PARTS & SERVICE NEWS

REF NO.	AA98114
DATE	JULY 22, 1998

SUBJECT: NEW ELBOWS, INDICATOR HOSE, & HOSE ROUTING

APPLICATION: WA500-1LE Wheel Loader with S/N A61001 and UP

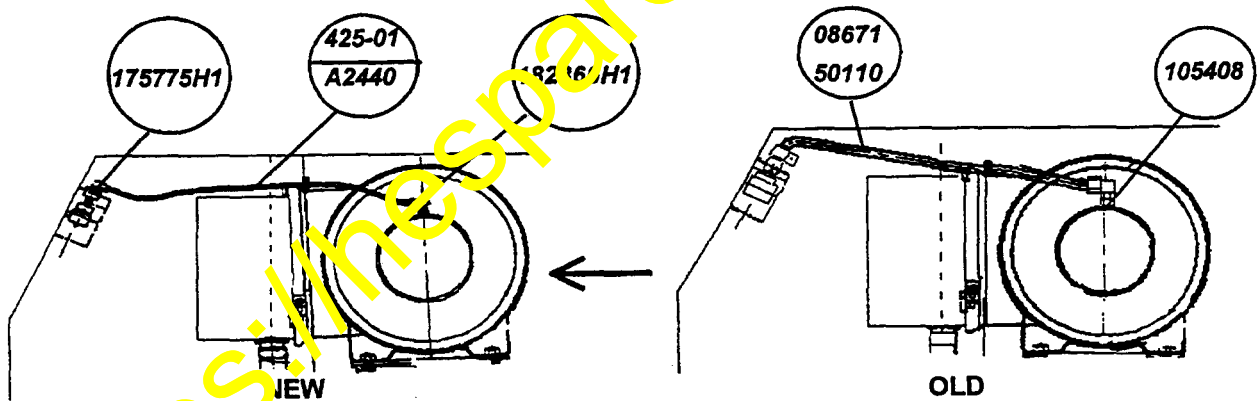
1. Add an elbow, p/n 175 775H1, to the air cleaner restriction indicator.
2. Replace the elbow, p/n 105 408, on the air filter housing with a new elbow, p/n 182 866 H1.
3. Replace the air cleaner indicator hose, p/n 08671-50110, with a new hose, p/n 425-01-A2440.
4. Route the new air cleaner indicator hose, p/n 425-01-A2440, so that it lies parallel to the top of the pre-cleaner housing. Refer to the NEW illustration on Page 1.
